**RE: Sundance Construction – Beverly Hills
Grading and Drainage Plan
Engineer’s Stamp Date: 01/24/18
Hydrology File: B18D023**

Based upon the information provided in your submittal received 01/24/18, the Grading and Drainage Plan **is not** approved for Building Permit. The following comments need to be addressed for approval of the above referenced project:

T:\Projects\17-015\Sundance\Beverly Hills\CAD\Sheet\17-020_Misc\17-020_Misc.dwg, Misc, Details_101817, C-501, 1/24/2018 1:57:50 PM, jlaporte, 1

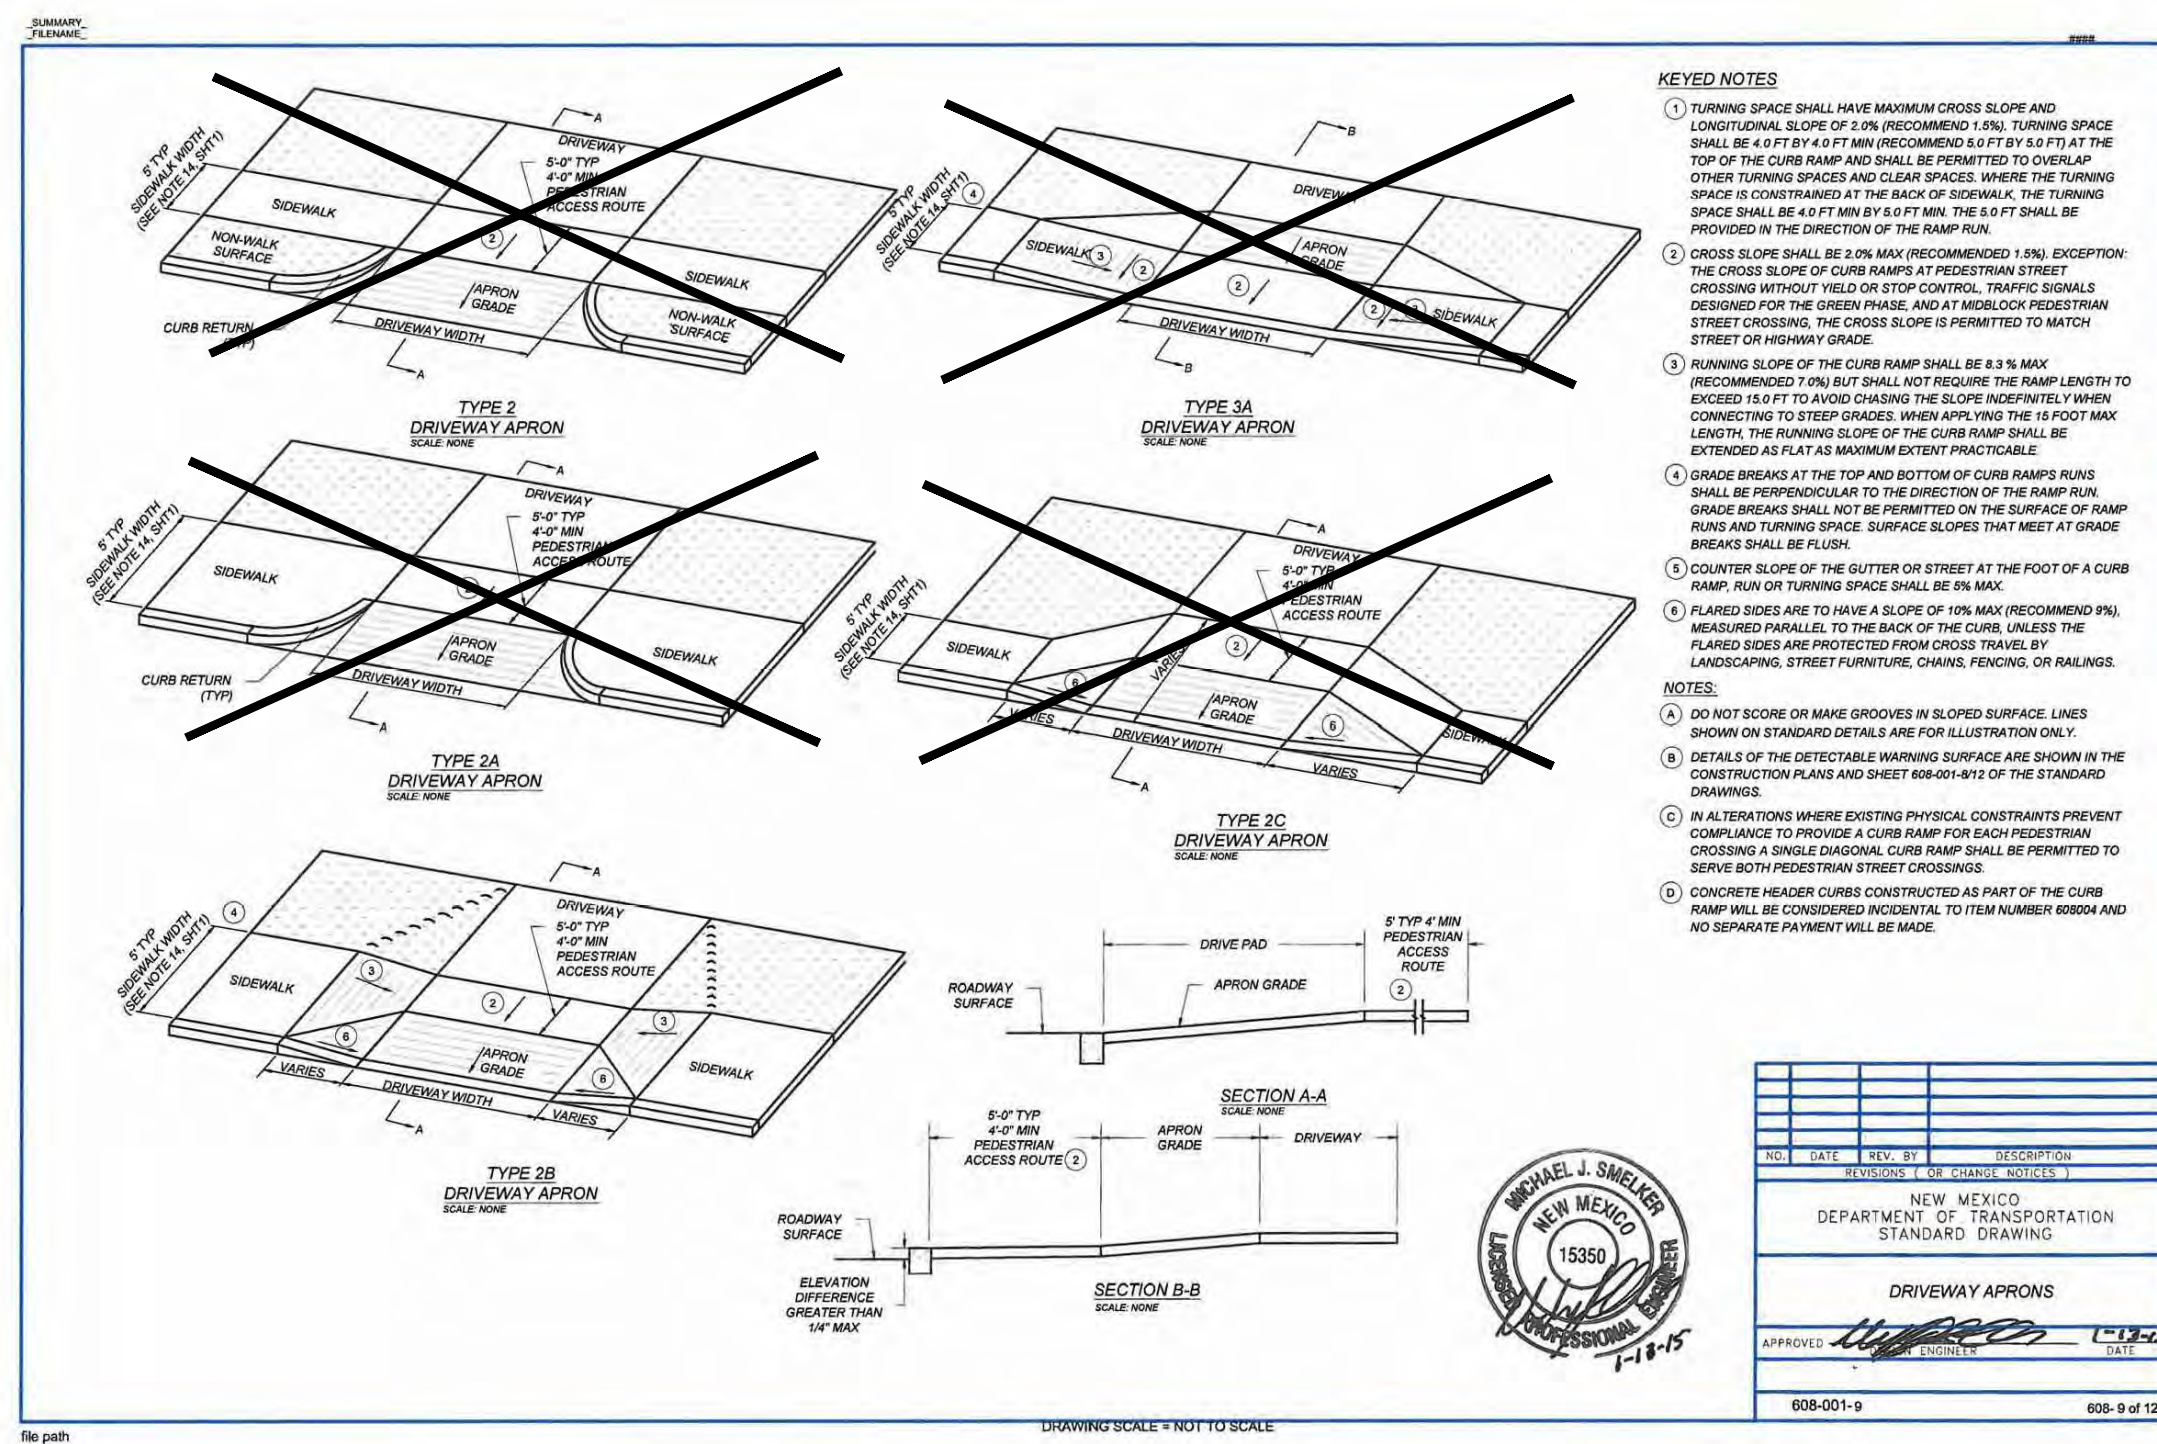
9. Sheet C-501. Where is the typical pond section detail used? If not needed, then please just delete.
